संख्या/No. TI/OHE/IRSDCL/2017

विषय/Sub: Modification in OHE in connection with Redevelopment of Railway Station.

3. Accordingly IRSDCL submitted the report "Modification in OHE in connection with redevelopment of Railway Stations-Version 6 dated 23.10.2017" duly incorporating the changes suggested by RDSO vide reference (iii) above. RDSO recommendations incorporating the Railway Board directives are reproduced below:

**Modification in OHE in connection
with the Redevelopment of
Railway Stations
Final Report**

Figure 4: OHE Support design for reduction in over line structure height

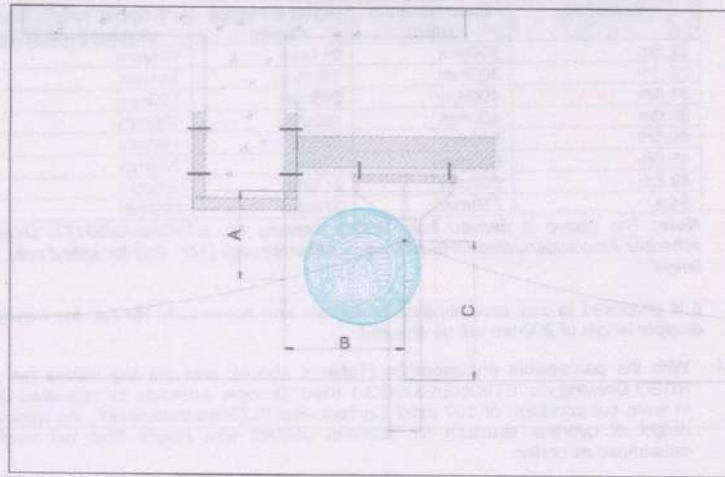
- (a) Standard height of contact wire shall be 5.6m.
- (b) In order to reduce the height of Overline structure (station concourse), Cantilever position under the Station Concourse as shown in Case II under para 4.3 of the report, have been recommended by IRSDCL. It is acceptable. However, along the track distance between the Cantilever and beam (distance named as B) should be minimum of 1000mm and not 750mm for considering rotation of Cantilever due to temperature variation.
